**CITY PLANNING COMMISSION**

- APPLICATION:
- Variance to waive one of 27 required parking spaces for a medical office addition in the General Commercial (C-2) zone. WITHDRAWN
  - Variance to waive the required six-foot solid masonry wall adjacent to the Single Family (R-1) zone.
  - Lot Line Adjustment to merge two parcels totaling 0.6± acres.

LOCATION: 4635 Freeport Boulevard

PROPOSAL: The applicant is requesting the necessary entitlements to add a medical office to an existing commercial medical office complex.

# SITE PLAN

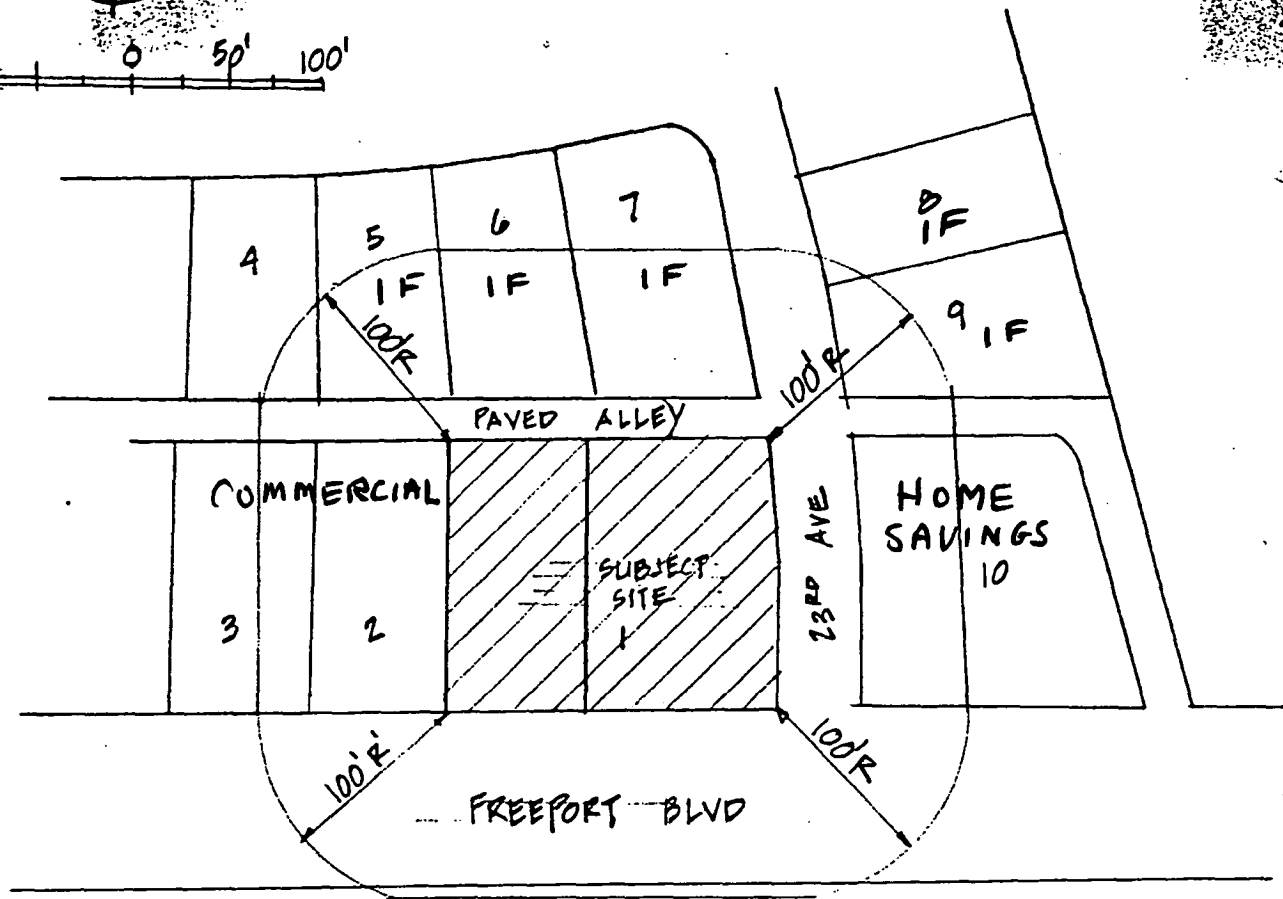
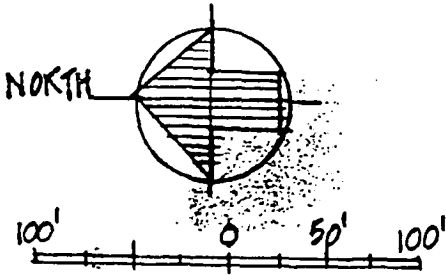
4. The site plan indicates that the applicant proposes to restripe and landscape the existing parking lot in the front of the site. The new parking spaces located along the alley must meet the required 50% shading and must be properly landscaped and irrigated. The site plan indicates a large open space on the northeast corner of the subject site. This area is presently overgrown with weeds and includes an open trash bin. Staff recommends that the applicant provide an enclosed trash container at this location and provide landscaping in the remaining open space to the rear of the structure.

5. The site plan was reviewed by the City Traffic Engineer who indicated that the driveway entrances must be improved to current City Code for commercial driveways. The Engineer also noted that the sidewalk next to the alley entrance was warped, due to an existing delivery ramp. The applicant is proposing to remove the ramp and replace the area with a landscaped planter. The Traffic Engineer indicated that the landscaped planter should be extended to the public sidewalk and that the sidewalk should be repaired. In reviewing the applicant's site plan, the Traffic Engineer noted that the sidewalk in front of the subject site, along Freeport Boulevard, is eight feet wide and that it would be advisable for the applicant to gain an irrevocable permit to use three feet of this space for the proposed landscape planter adjacent to the parking lot. The required sidewalk width in this area is five feet, and this site is the only one on this block face which is developed with an eight-foot wide sidewalk. This will provide for a larger planter strip which will accommodate shade trees and will also increase the parking and maneuvering area in the existing parking lot. Also, the applicant should be aware that the maneuvering space for the northerly parking spaces (spaces 4 & 5) must be 26 feet.

- d. The applicant shall redesign the on-site parking layout and provide 27 spaces as indicated on Exhibit C;
- e. The applicant shall submit detailed floor plans of the proposed addition to the Planning Director for review and approval prior to issuance of a building permit. The plans shall indicate the proposed uses in the office addition. Medical and dental office space shall be limited to 1,736 square feet.
